EES Inquiry and Advisory Committee Report

Edithvale and Bonbeach Level Crossing Removal Projects

30 July 2018

Figure 5 Conceptual model of groundwater systems in the study area⁷

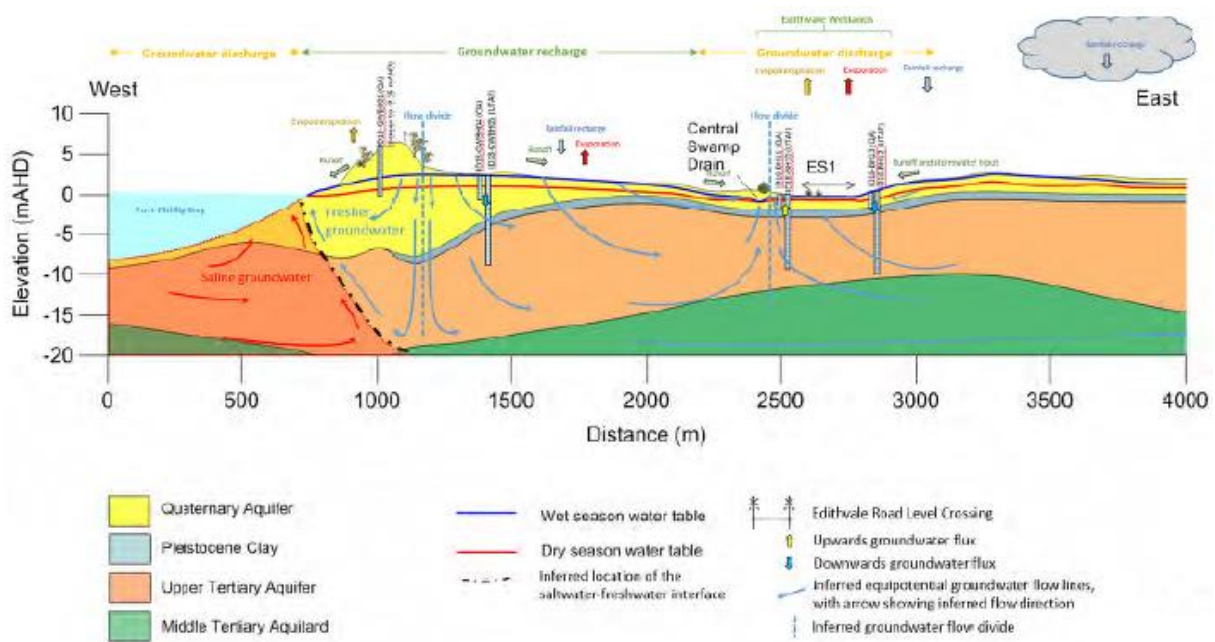
Dr Woinarski (expert witness called by Council) agreed with the general conceptualisation of the groundwater systems presented in the EES, although he noted that he did not have access to the bore logs for many of the relevant boreholes used for the EES, which prevented him from providing a more a detailed assessment⁵. He noted that:

The extent of Pleistocene clays at the base of the Quaternary sediments in the study area was not clearly shown (and its inferred thinning to the west and absence in the northern area of the wetlands was not clearly incorporated in the flow model). The extent and thickness of clay-rich sediments in the Quaternary sediments may significantly change the sensitivity of recharge of the Edithvale swamp associated with lowering of the water table associated with construction activities⁶.
